UNITED STATES PATENT AND TRADEMARK OFFICE

APPLICATION NO.	FILING DATE	FIRST NAMED INVENTOR	ATTORNEY DOCKET NO.	CONFIRMATION NO.
09/912,460	07/26/2001	Tatsuya Kawahara	77661/55	5110
23838	7590	10/30/2003	EXAMINER	
KENYON & KENYON 1500 K STREET, N.W., SUITE 700 WASHINGTON, DC 20005			CANTELMO, GREGG	
			ART UNIT	PAPER NUMBER
			1745	
DATE MAILED: 10/30/2003

Office Action Summary

DETAILED ACTION

Fig. 2

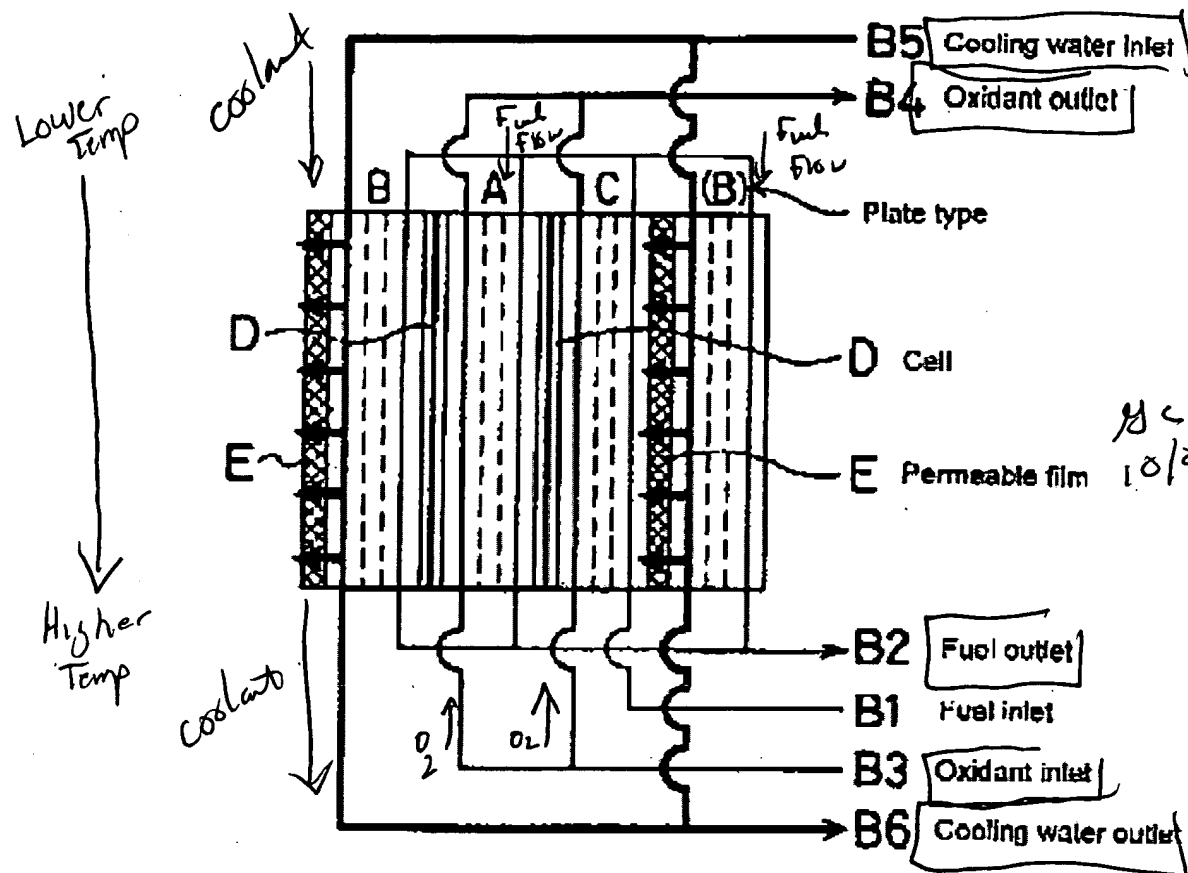
Fig. 2 above discloses a fuel cell including a high temperature portion and a low temperature portion in a cell plane comprising: an oxidant passage B3 formed in the fuel cell wherein an oxidant gas flow is directed within the oxidant passage from the high temperature portion to the low temperature portion of the fuel cell (marked up Fig. 2 as applied to claim 1).

The low temperature portion is located at a higher position than the high-temperature portion (marked up Fig. 2 as applied to claim 2).

Multiple fuel gas passages are formed in the fuel cell with the fuel gas flow being directed both from the low-temperature portion to the high-temperature portion at the initial introduction of the fuel to the fuel cell and then back through the fuel cell from the high-temperature portion to the low temperature portion. This is evident from the fact that both the fuel inlet and outlet exist on the same end of the stack and thus the fuel is directed in a return path as shown in Fig. 2 (as applied to claim 8).

Along the return path the fuel inlet back into the cell is directed from the low-temperature portion to the high-temperature portion and the return path outlet is lower than the return path inlet (marked up Fig. 2 as applied to claim 9).

Yoshimoto does not explicitly disclose of oxidant gas flow directed from the high-temperature portion to the low-temperature portion so that water produced during operation of the fuel cell will recirculate in the oxidant passage (claim 1) or that the flow of the oxidant is reverse to the direction of gravity (claim 3).

Although Yoshimoto does not explicitly recite this language, the arrangement of the fuel cell and channels and further of the direction of the oxidant relative to the coolant (being counter-current as embodied in the instant application) provides evidence of a reasonable expectation that the prior art arrangement will cause at least a portion of water produced during operation of the fuel cell to recirculate in the oxidant passage and thereby humidify the oxidant gas in the oxidant gas channel (Fig. 2 as applied to claim 1).

The arrangement of claim 3 shows a stack arrangement wherein the gas channels are vertically arranged. Therefore the flow of gases is shown to either be

upward in a vertical direction (oxidant) or downward in a vertical direction (coolant). The arrangement shown therein teaches of a vertical configuration, which as a result, would cause the oxidant flow to obviously, if not, inherently be flown up from the bottom of the stack and therefore in opposition to the direction of gravity (Fig. 2 as applied to claim 2).

With respect to the newly applied rejection, it is considered that the arrangement of Yoshimoto as shown in Fig. 2 for example, has the same structural arrangement and claimed direction flow of oxidant, fuel and coolant to provide the same functions as recited in the rejected claims, absent clear evidence to the contrary.
